SUBJECT: Addendum No. 4

RE: Invitation to Bid (ITB) Solicitation No. H93-IAHDRR-2024-026, IAH Terminal D Restroom Renovation at Multiple Gates at George Bush Intercontinental Airport (IAH); Project No. 971

IAH Terminal D Restroom Renovation at Multiple Gates at George Bush Intercontinental Airport (IAH)

This revision is a clarification of fixtures, finishes and MEP changes. All sheets now show the TIP/BSG numbers on the TTB. This clarification involves the following documents:

A1 SECTION DETAIL @ SINGLE SIDE SINK STATION
SCALE: 1 1/2" = 1'-0"

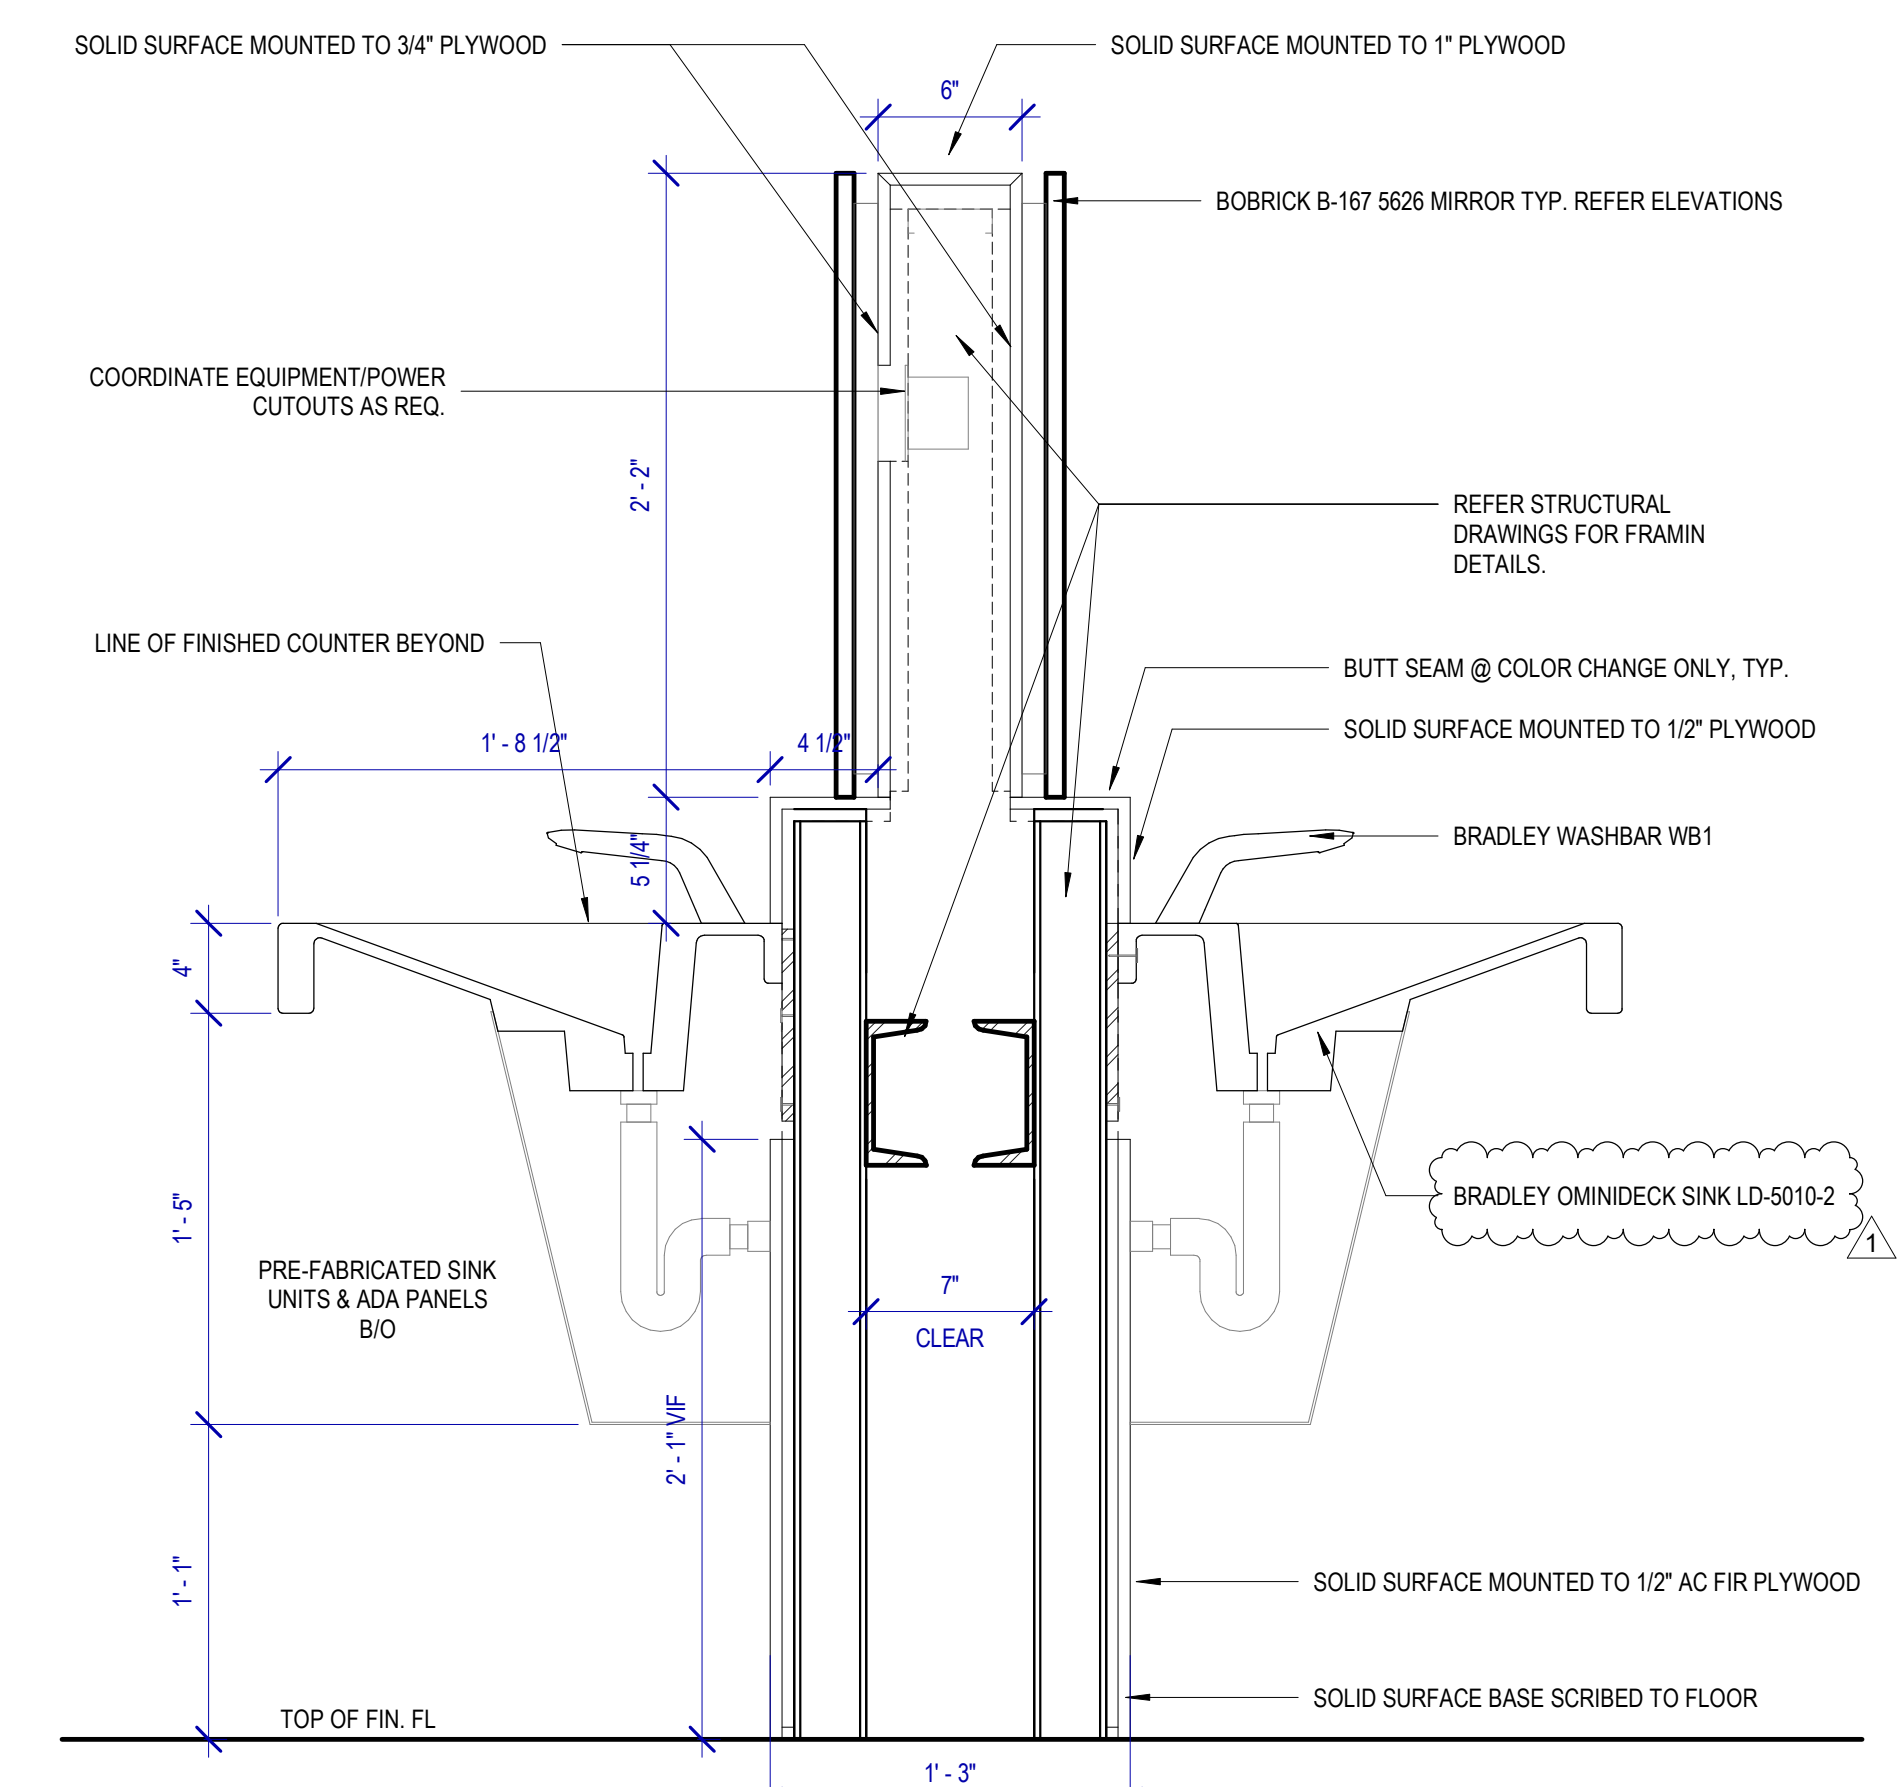
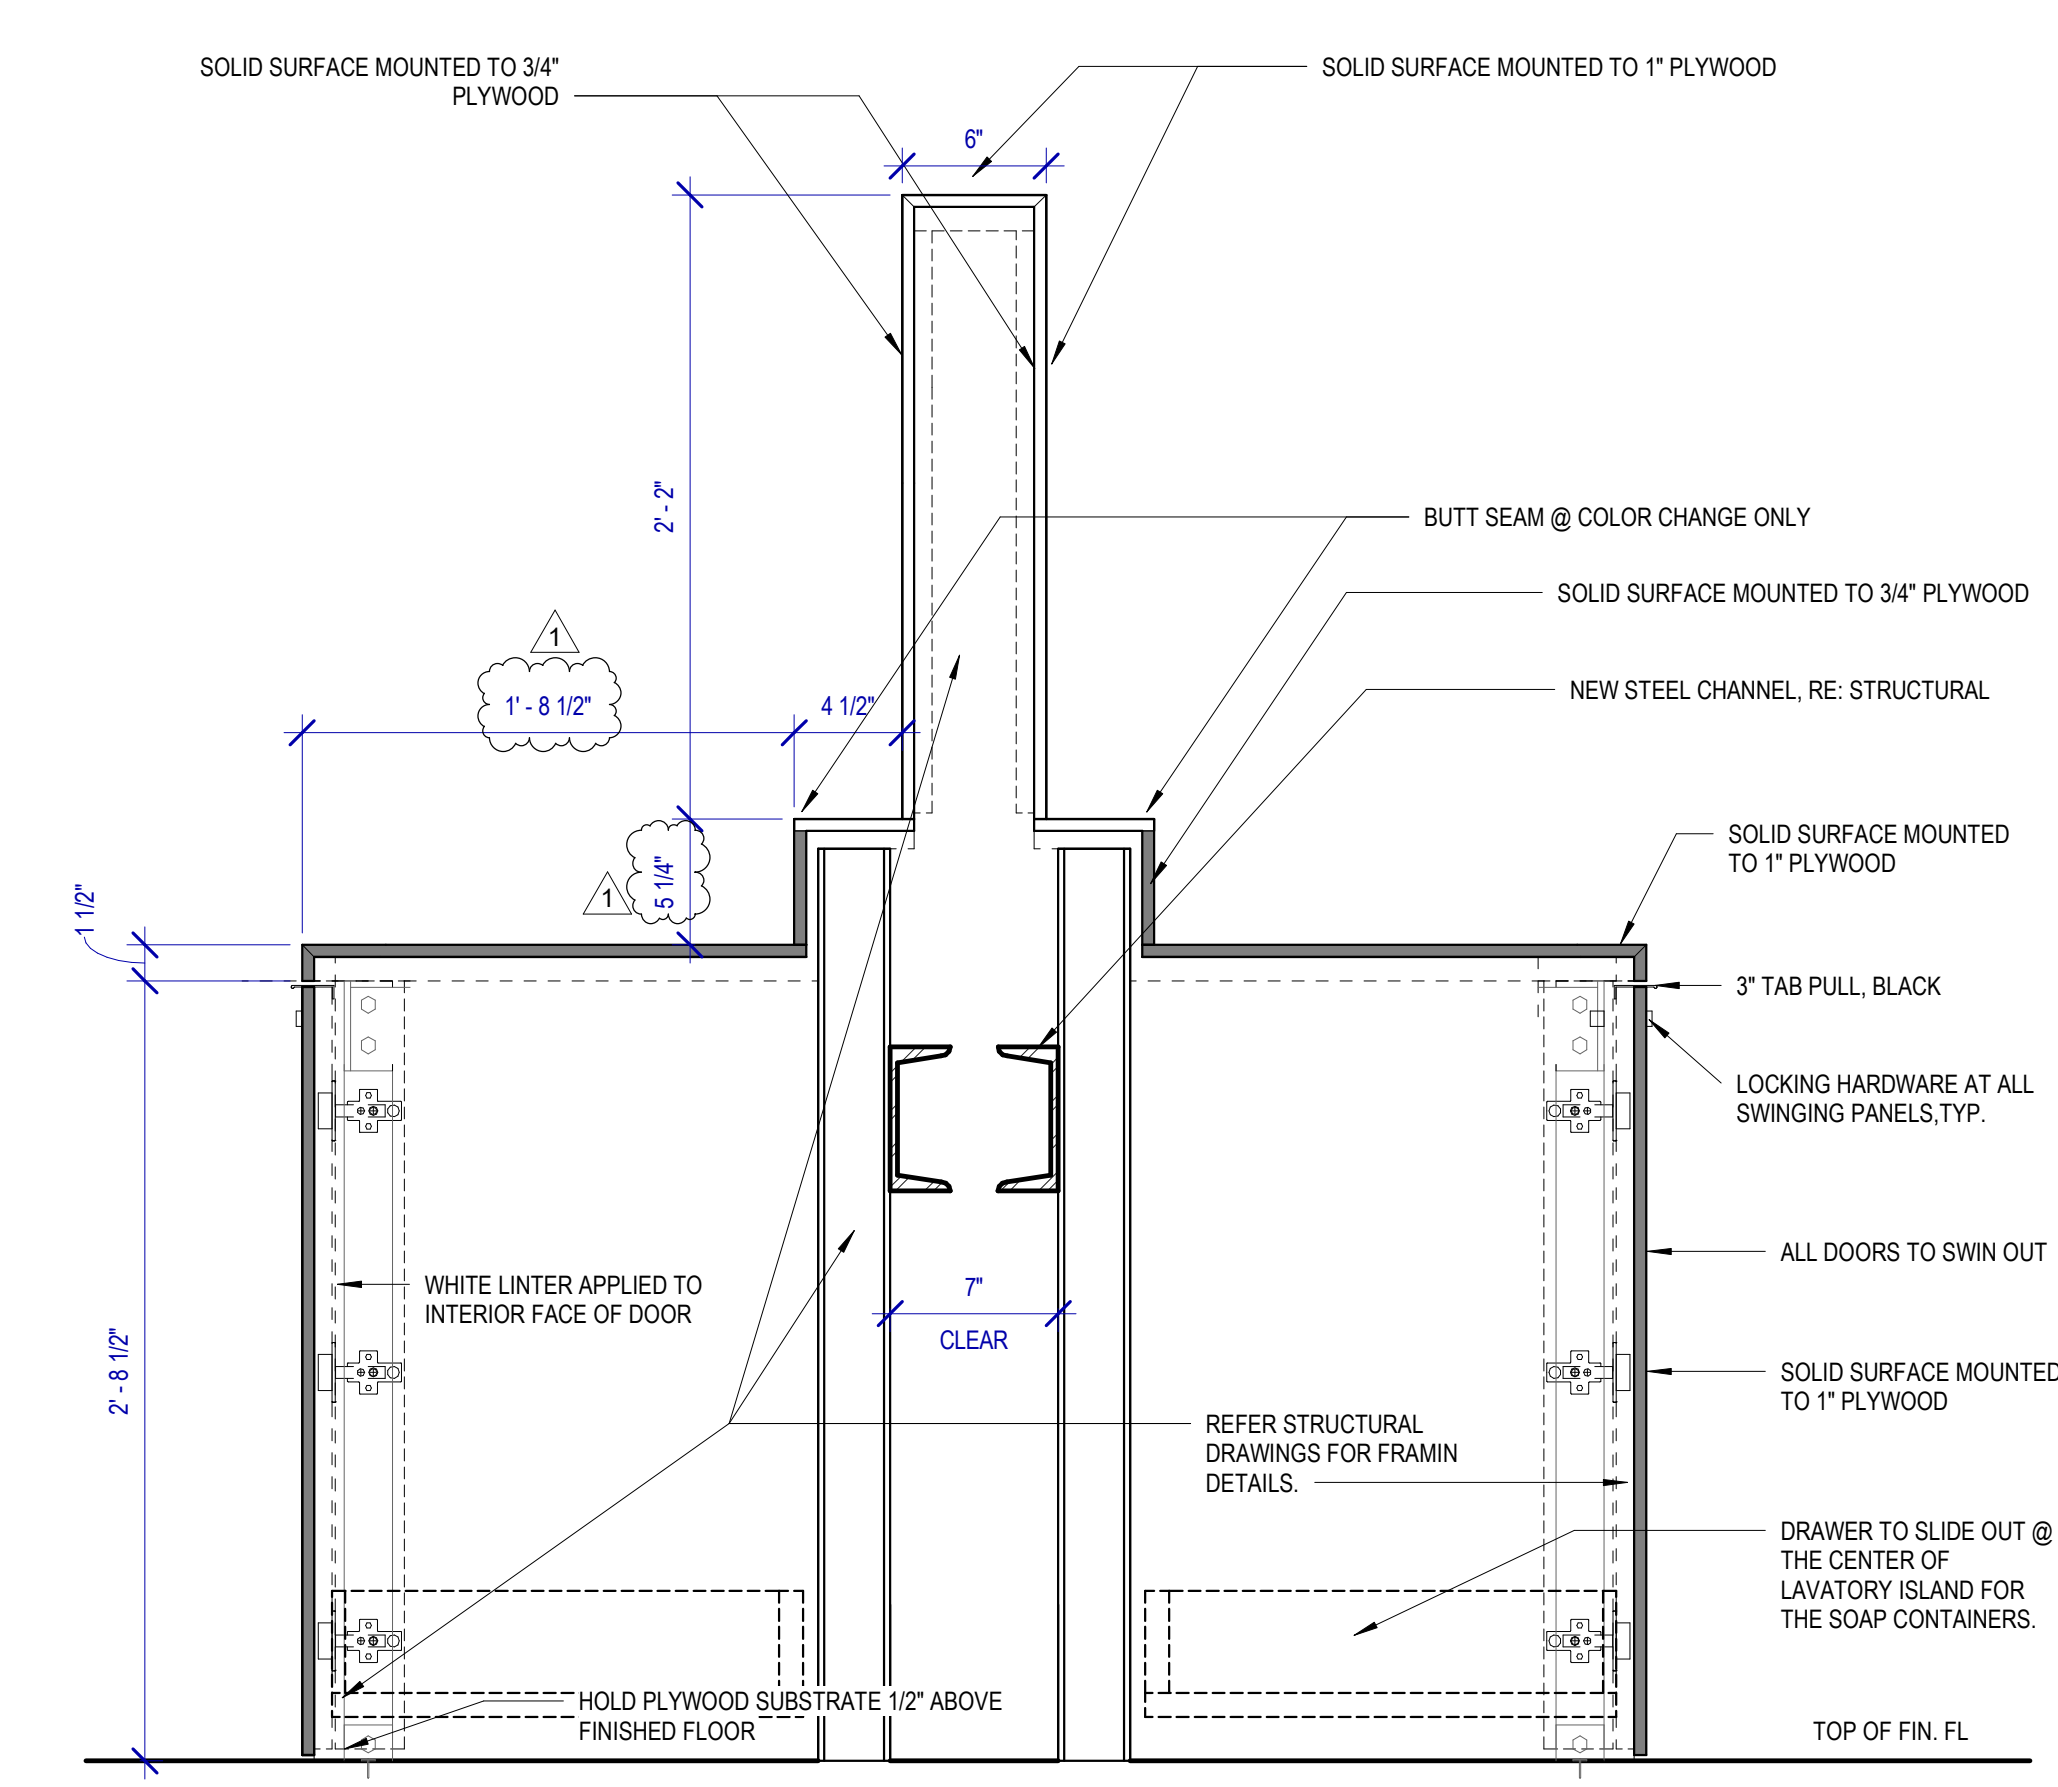
A-511: revised details dimensions and fixtures.
